Proposed Revisions to a Standard Plans Index

Index Number: 700-110

Index Title: MOUNTING EXIT NUMBER PANELS TO SIGNS

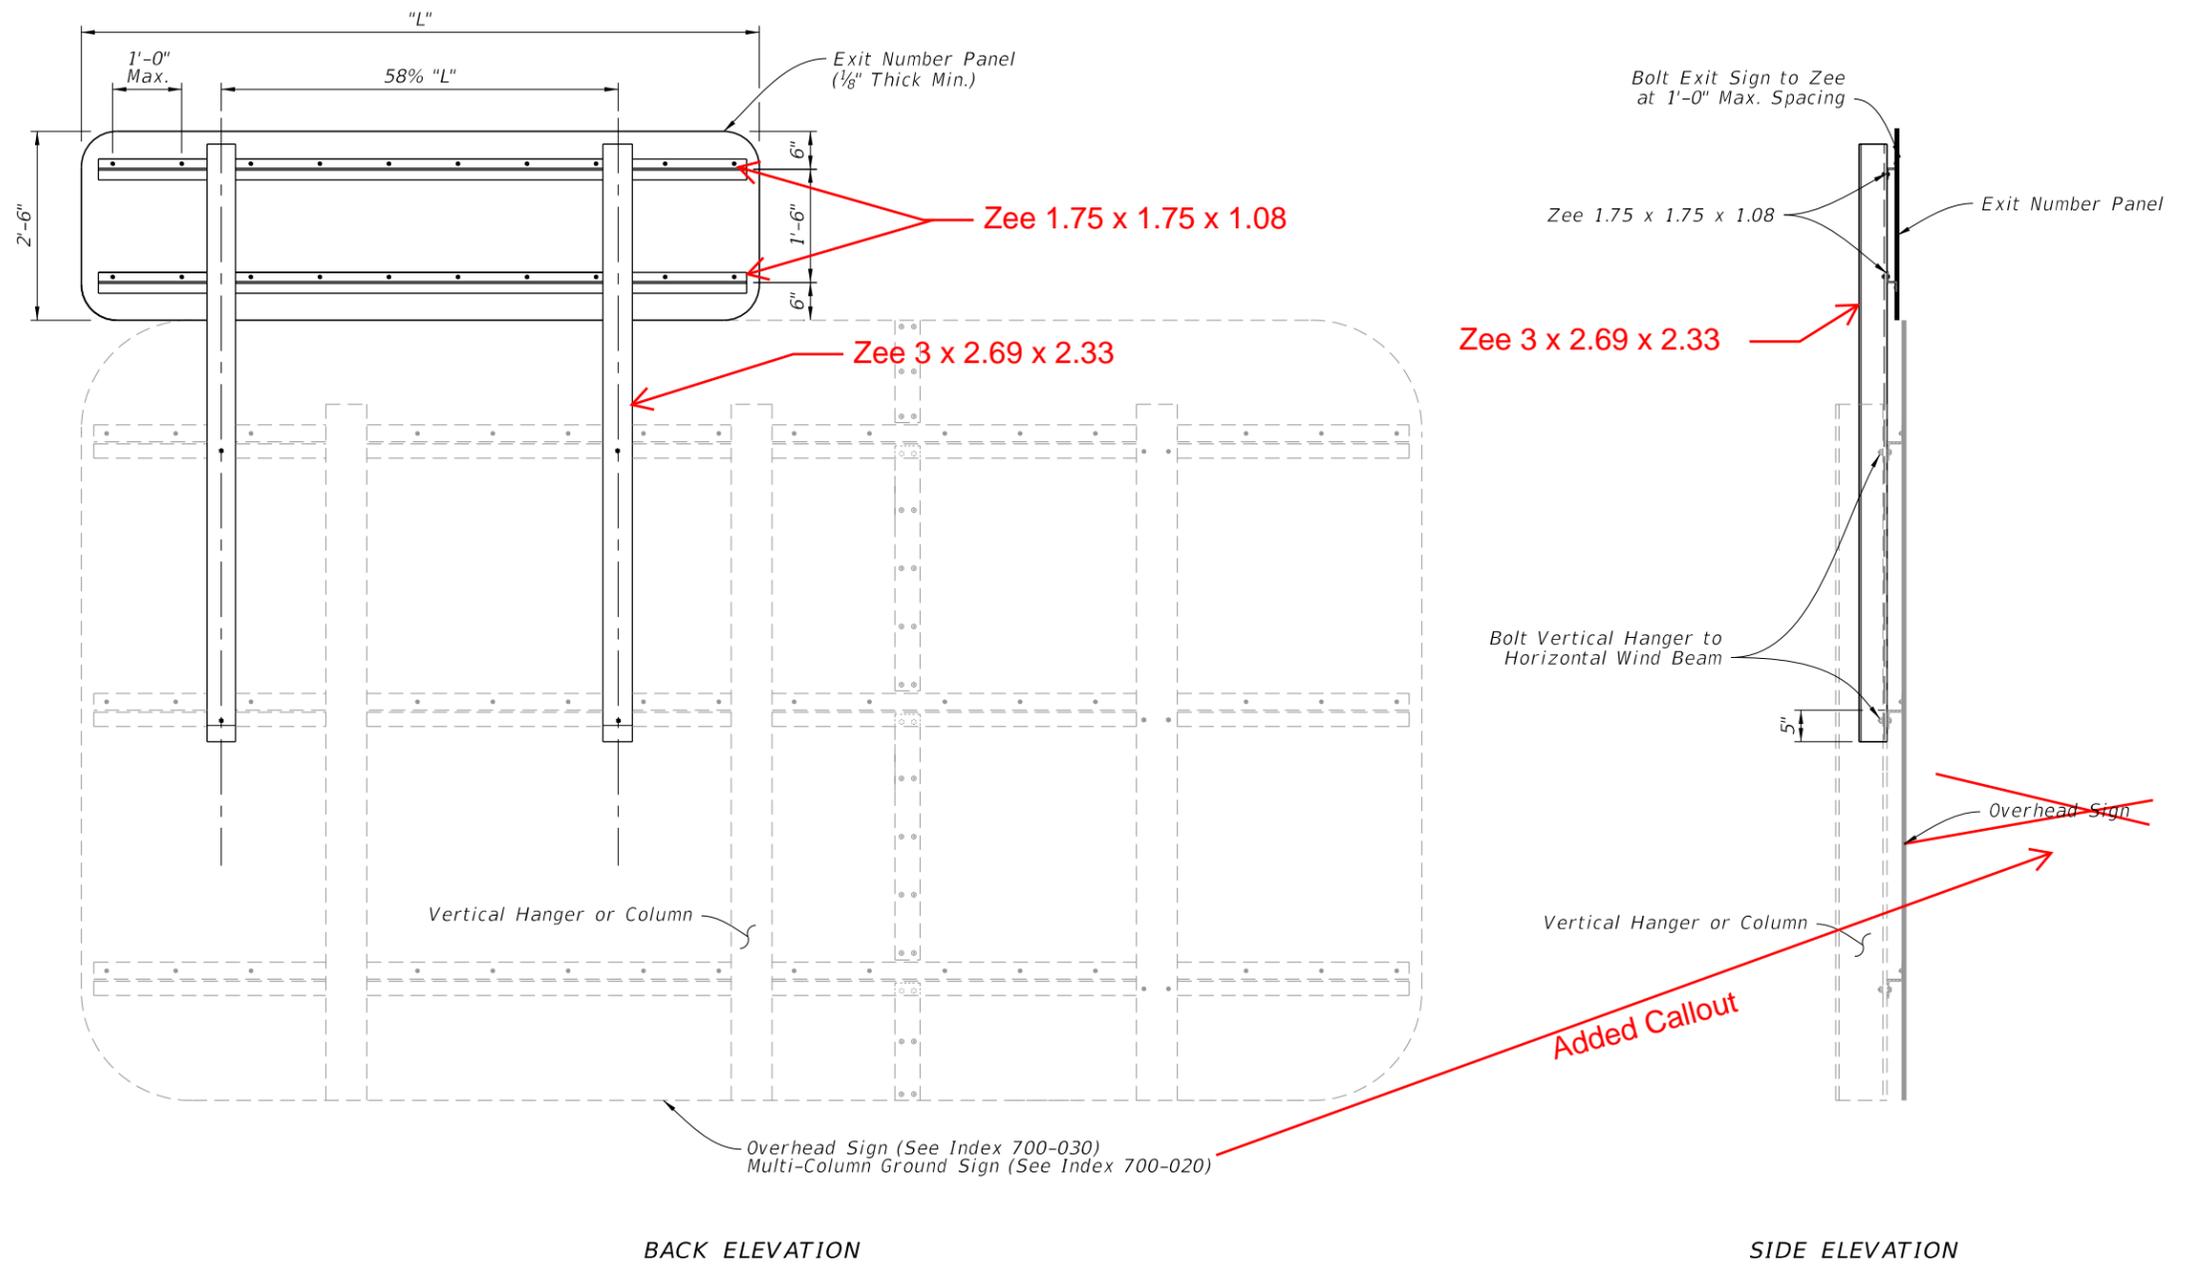
Sheet 1: Added missing callout; Added additional callouts for clarity.

This Standard was modified around 2018 and a callout was not copied over as required. We added the missing callout and made some minor callout changes for clarity.
